Town of Indian Trail

Memo

SUBJECT: **Caliber Collision**
Landscaping and Tree Protection Plans

ATTACHMENT 1: Alternative Landscape Plan

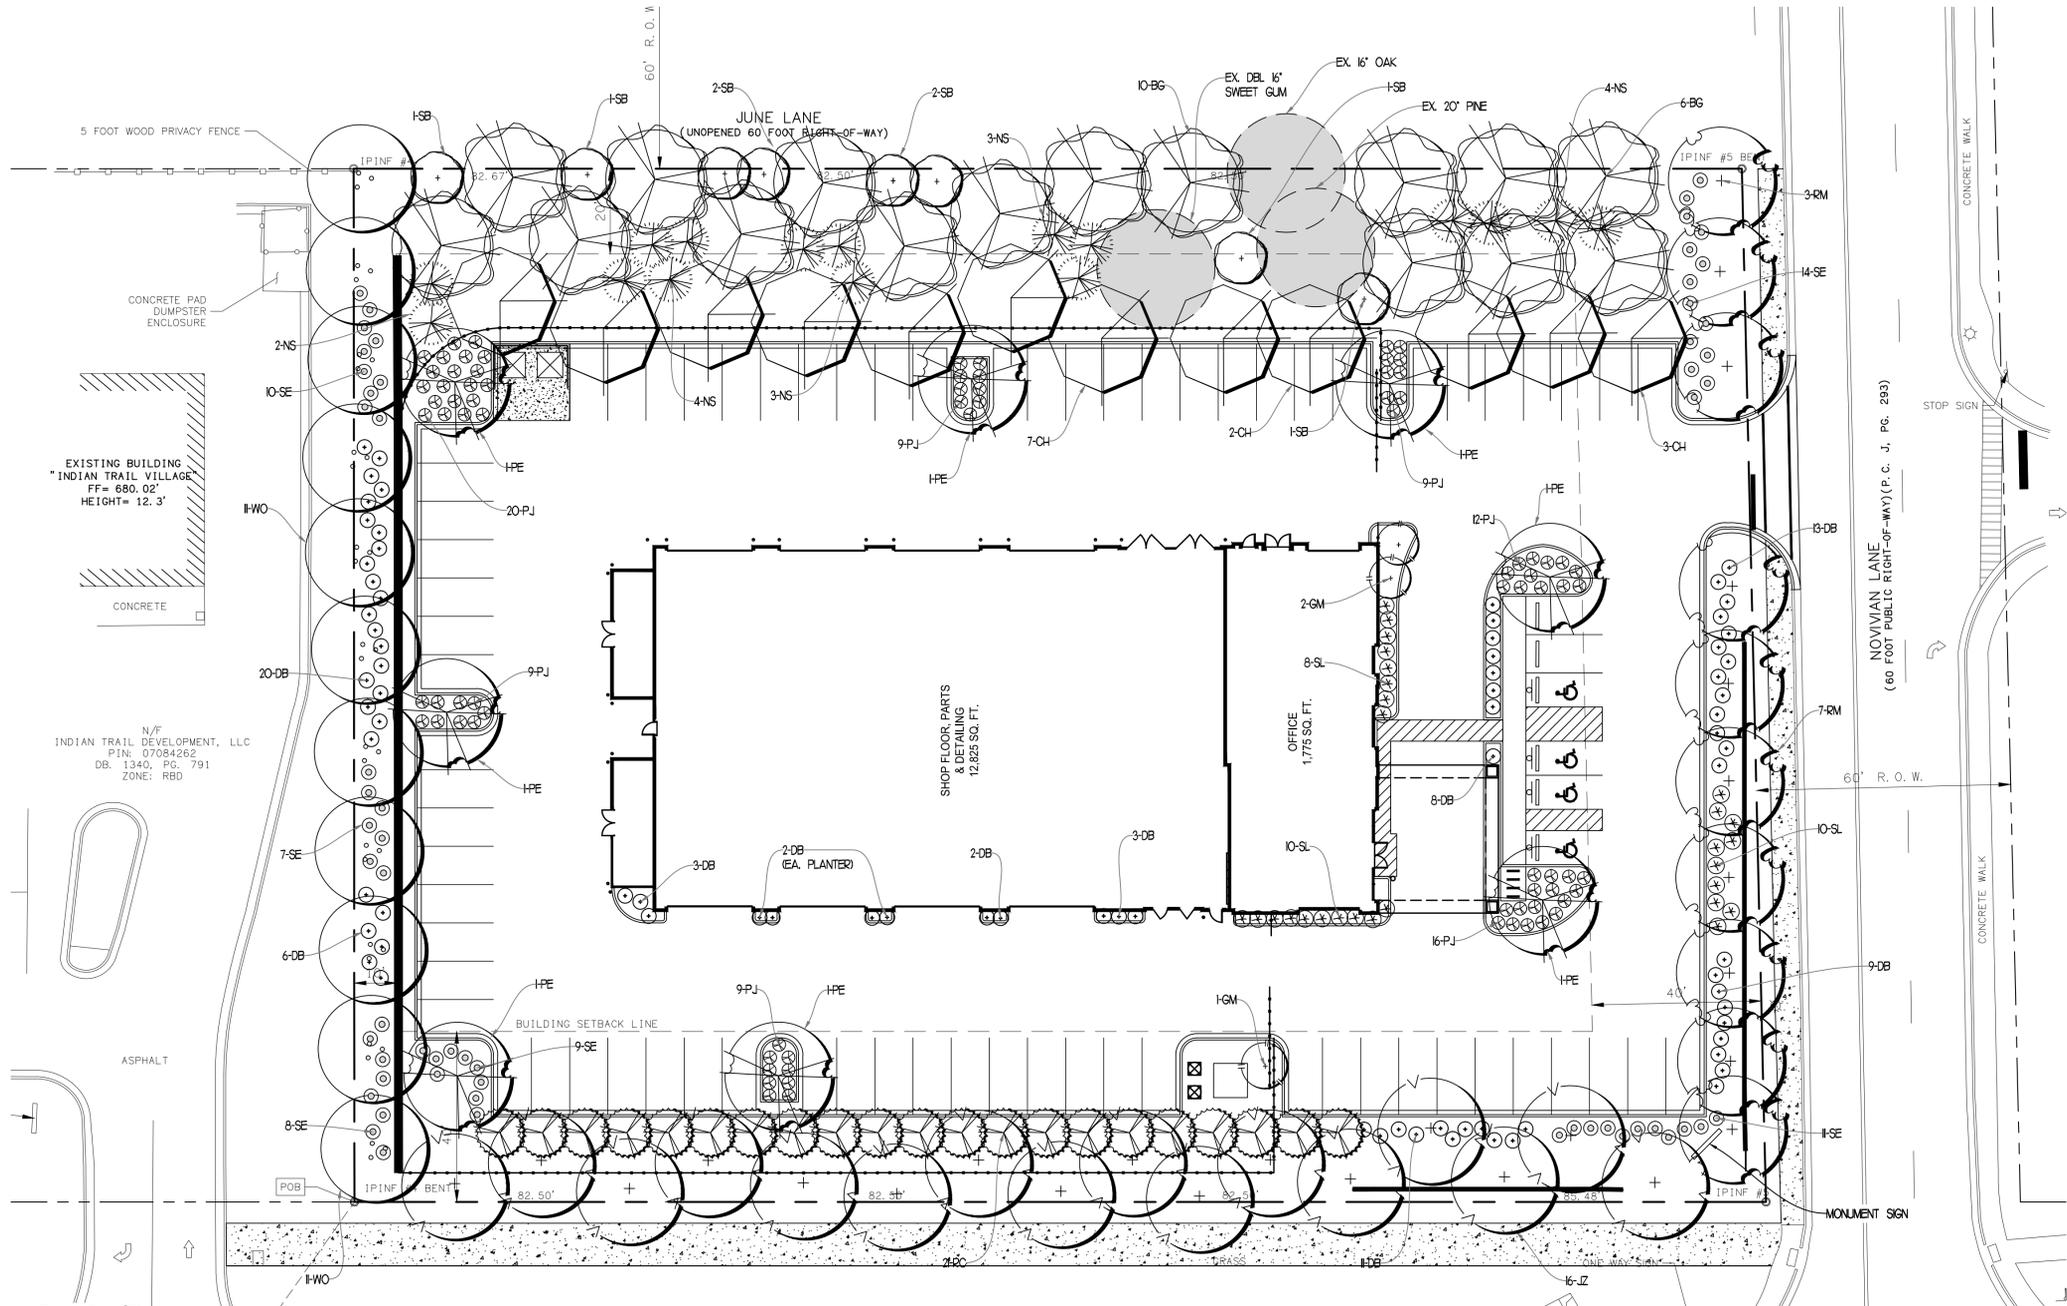
In light of the lot configuration and grade related issues, Caliber Collision is proposing an enhanced 40-ft vegetated buffer (see Attachment 1). The building will be located approximately 90-ft from the property line and while some of the vehicle repair bays will be oriented towards the residential property, Caliber Collision's protocol is to have all bay doors closed once the vehicles are inside. This will help to eliminate any additional noise beyond the normal sounds coming from Highway 74. The buffer will consist of a mixture of evergreen and deciduous trees creating an almost opaque screening using a combination of Nellie Stevens Holly, Autumn Brilliance Serviceberry, Black Gum, October Glory Red Maple, Common Hackberry, and Princeton Elm. All of these species are listed below in greater detail (see Attachment 2). As part of Caliber Collision's insurance requirements, they will have a security fence installed at the tree line to prevent anyone from entering the storage area. The applicant will provide specific detail regarding the fencing and design of the retaining walls that will be used on site.

Tree Canopy Retention: The UDO requires that commercial sites retain or plant a min. of 10% of their site area as tree canopy. The UDO requires a minimum of approximately 8,011 sq. ft. of tree canopy to be retained for this subject property. As reflected in Attachment 1, the plan proposes an approx. 6,400 sq. ft. of tree retention area; however, the area where the trees are retained, additional trees will be planted to bring the site into compliance. At full maturity the tree canopy equal approximately 123,200 sq. ft. which includes; parking lot coverage, buffers and planting adjacent to the building. The plan places a priority on planting larger canopy trees, where appropriate, to help enlarge the tree canopy.

1. A retaining wall will be constructed along the side where the Indian Trail Villages shopping center is located. The separation from the top of the wall closest to the property line and the storage area for Caliber Collision is approximately 12-ft in height; and

2. The retaining wall will be a decorative design that incorporates the blocks and fencing to provide both aesthetics and function; and
3. While the storage/parking area will be lower than the adjacent property. The 10-ft side landscape buffer will consist of evergreen shrubs and Willow Oaks approximately 25-ft apart; and

4. Street side of storage area will have a row of Eastern Red Cedar trees planted approximately 10-ft on center; and
5. The rear buffer will incorporate a 3-layer approach to screening the site. Closest to the property line, a row of Black Gum, and Serviceberries. The second row will consist of Nellie Stevens Holly's clustered to provide the larger evergreen portion of the buffer. Lastly, closest to the storage area, the common hackberry; and

6. The grading design and use of retaining walls will help to minimize severity of side slopes.
